New Asia Fashions Ltd.

43/3 Anowar Jong Road, Charabag, Ashulia, Savar, Dhaka
(23.885858 N, 90.309833 E)
18th September 2017

Observation

Footing Layout Plan

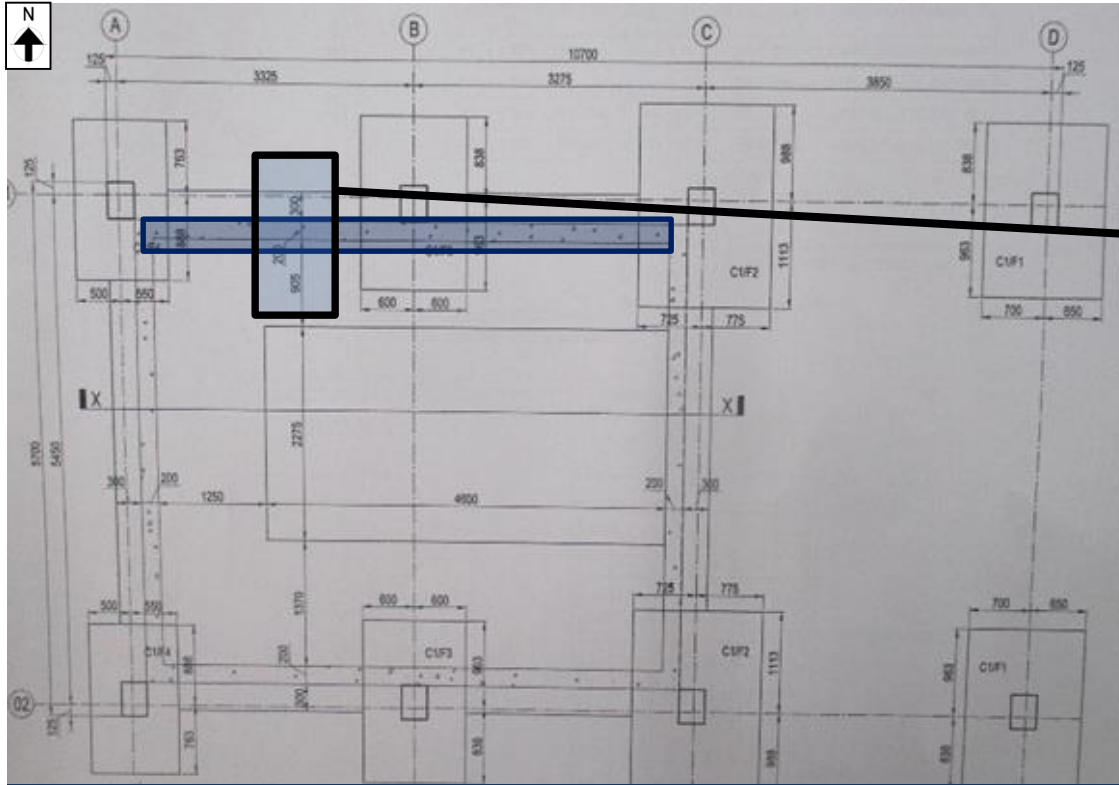
Discrepancy observed between As built drawing and on site condition

Thickness observed 100 mm

During inspection, Thickness of the retaining wall of the north portion of the building-4 was found 100mm instead of 200mm. Factory is required to revise structural drawing as per site condition and adequacy check required to carryout.
